ADDENDUM 1
TOWN OF SIMSBURY
Request for Proposal
FOR
DPW Fire Protection System

Addendum #1
DPW Fire Protection System

SCHEME D

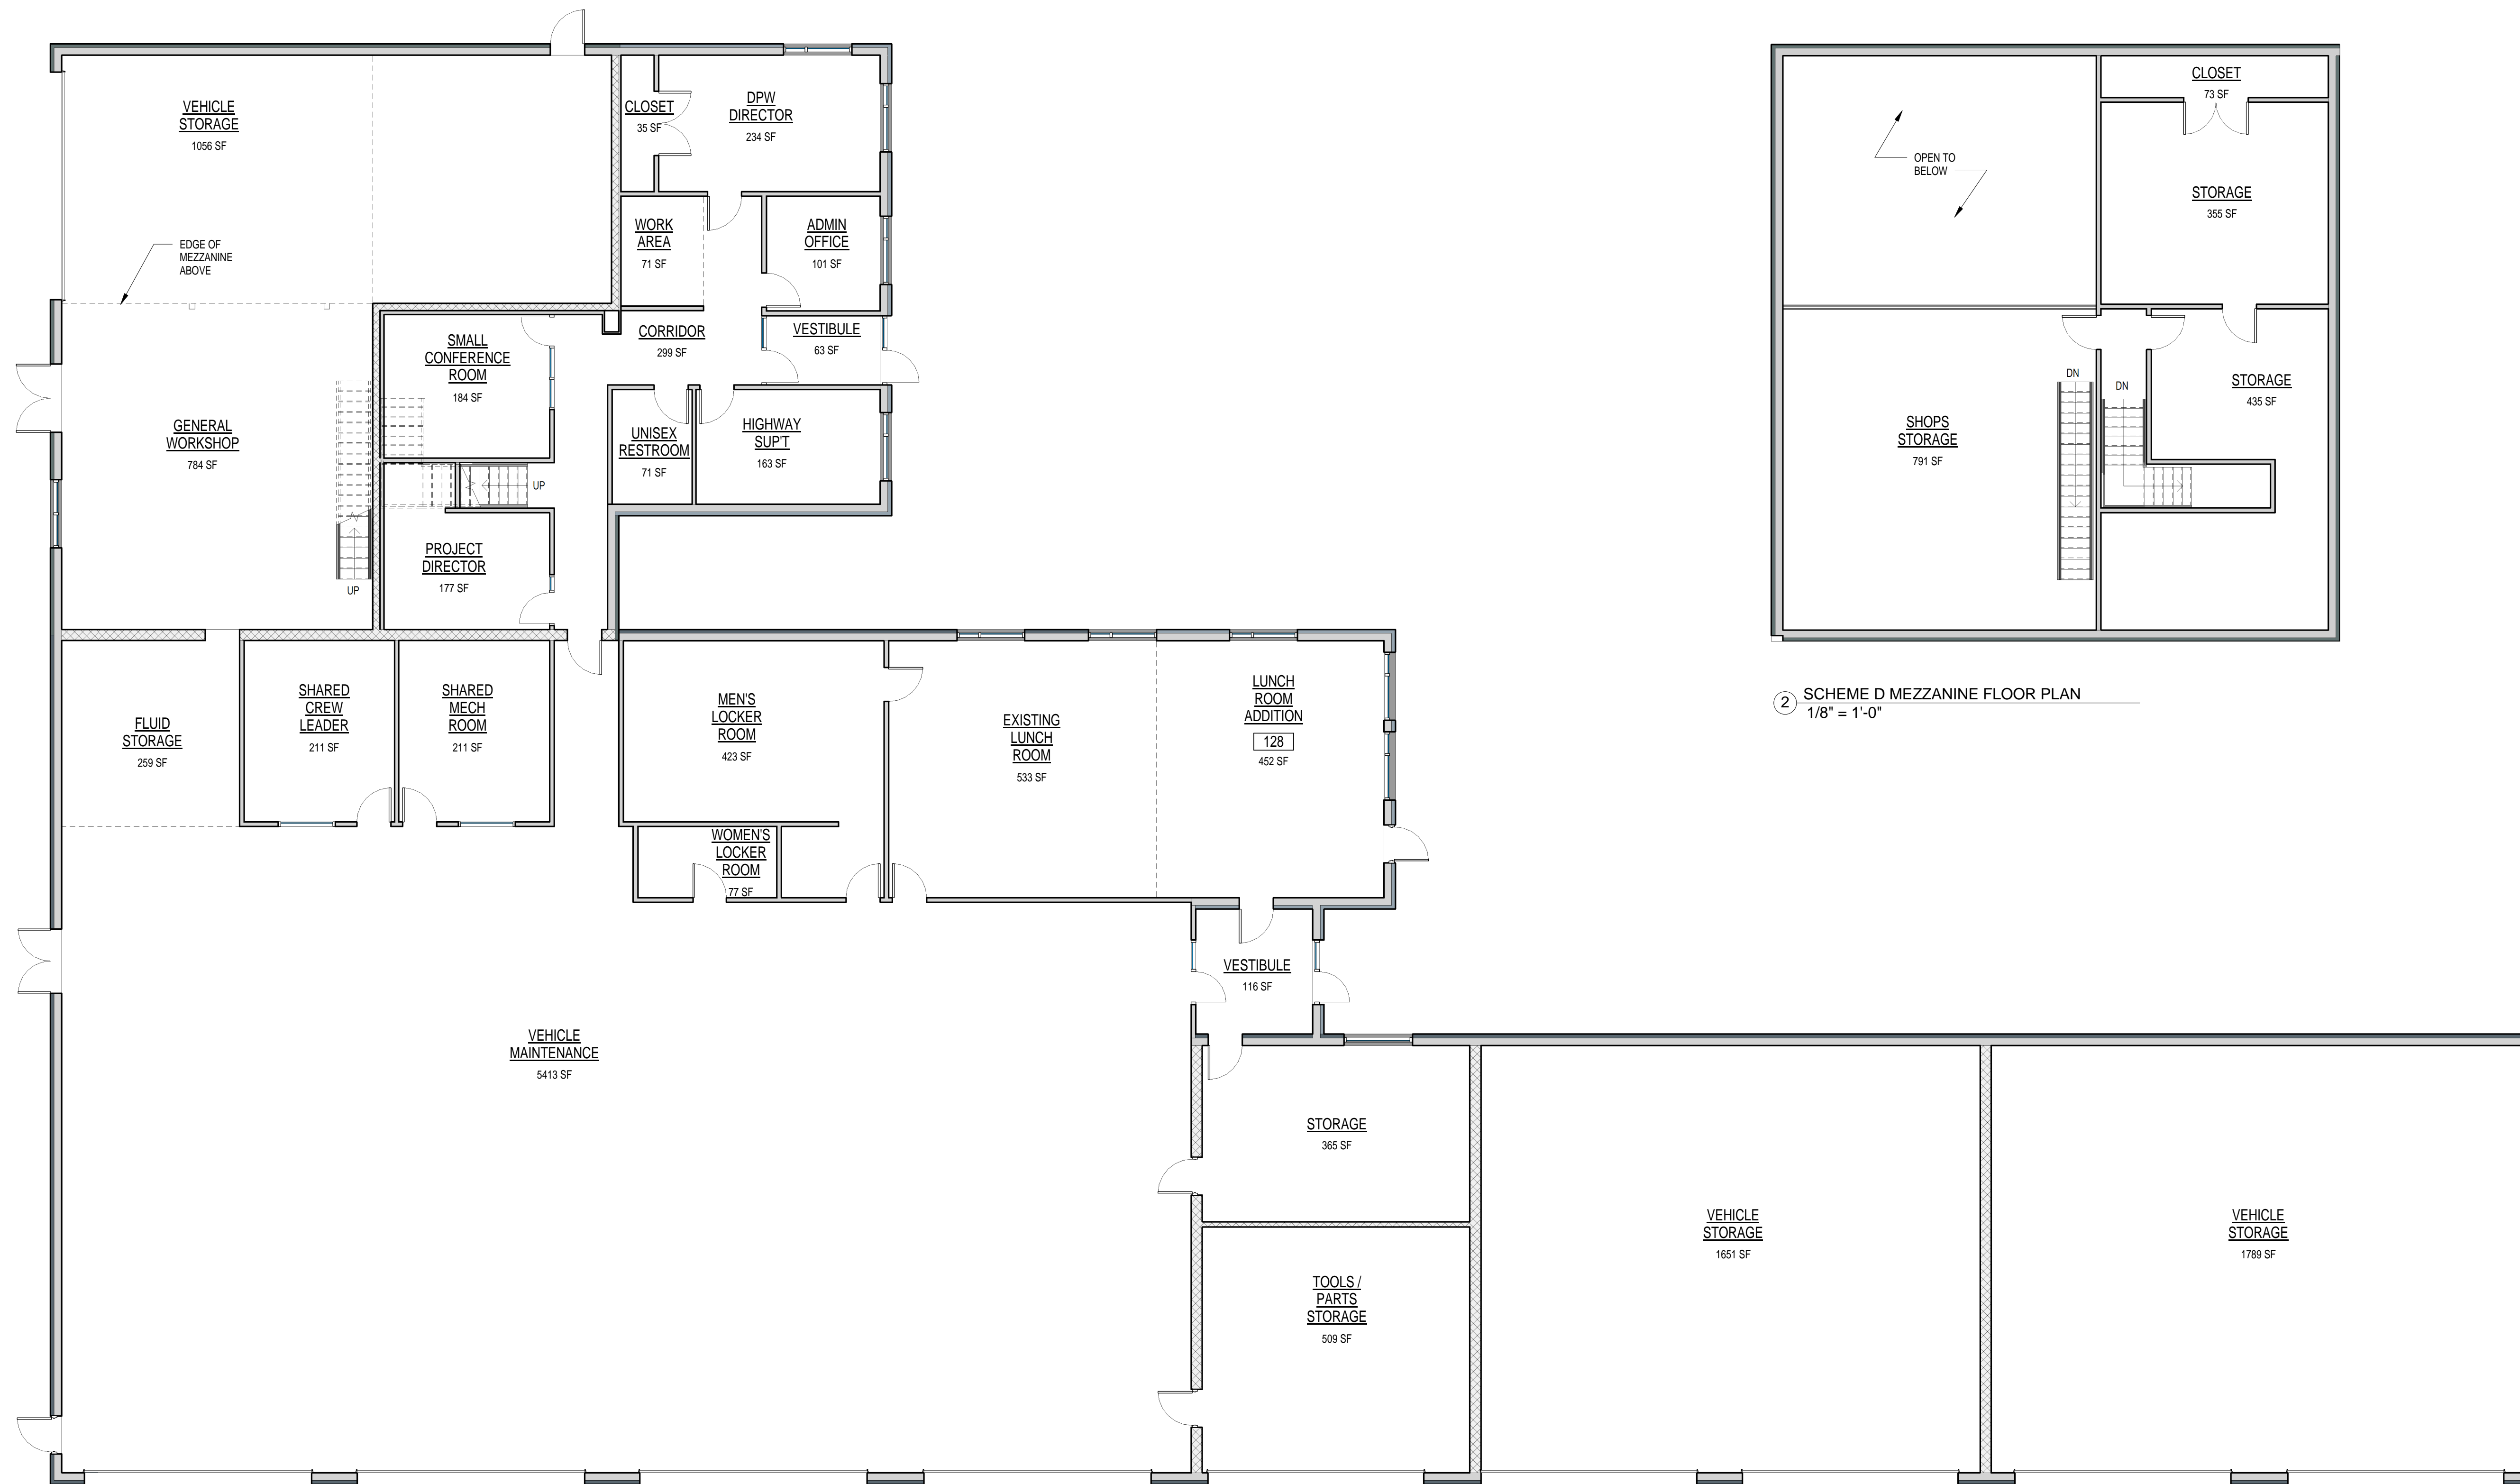
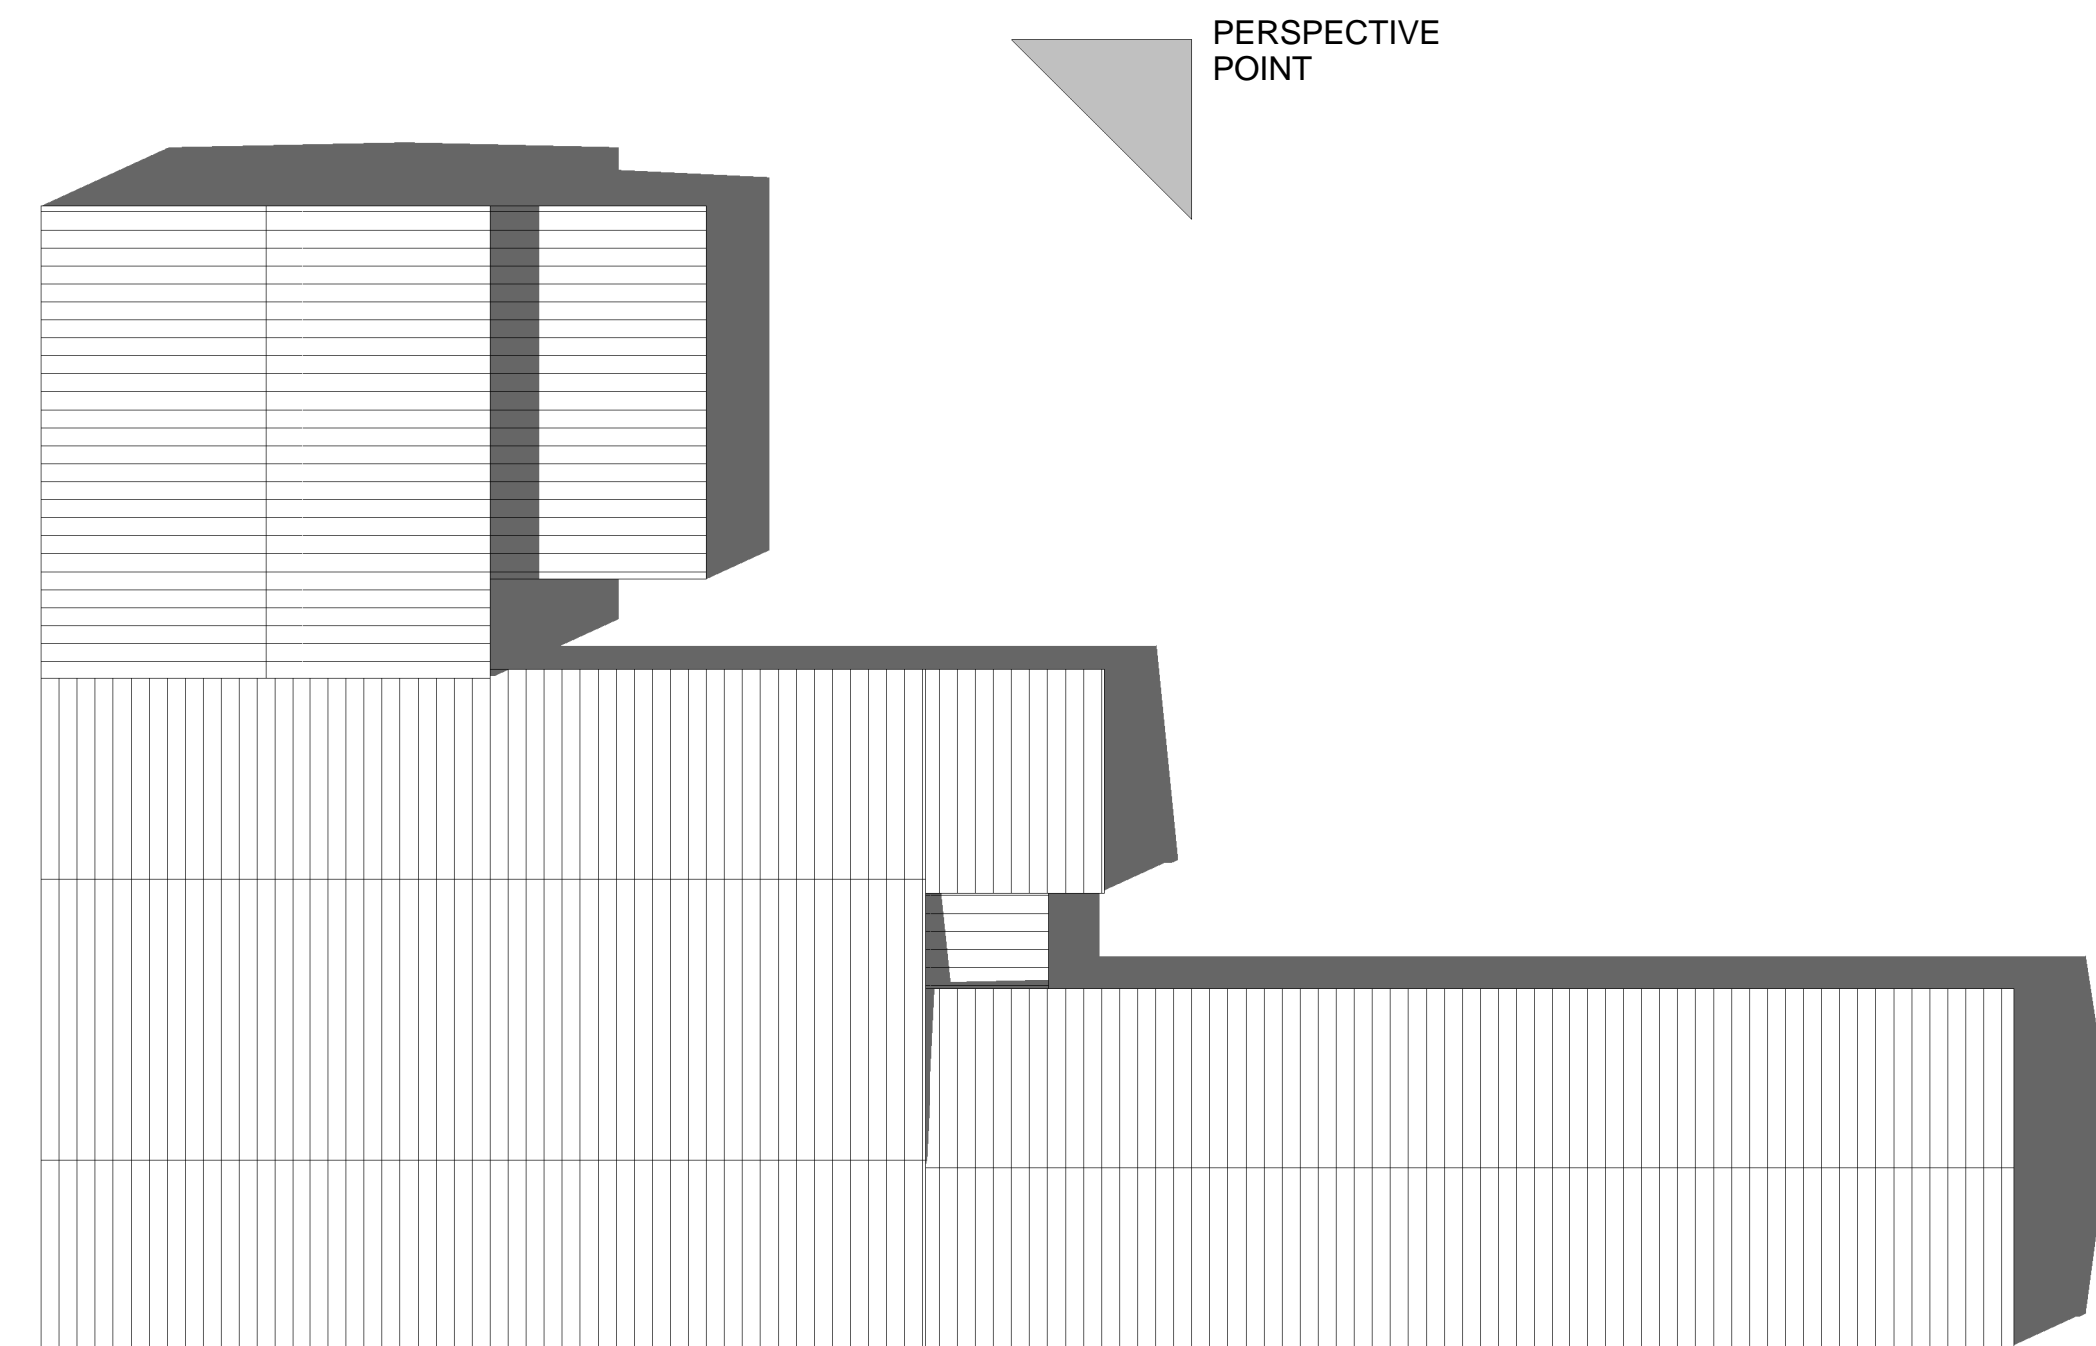
The fire sprinkler system must allow for future expansion of the main public works building as shown on the attached preliminary design sketches, depicting the addition of 450 sf to the east of the lunch room and 1,050 sf being added to the east of the office area.
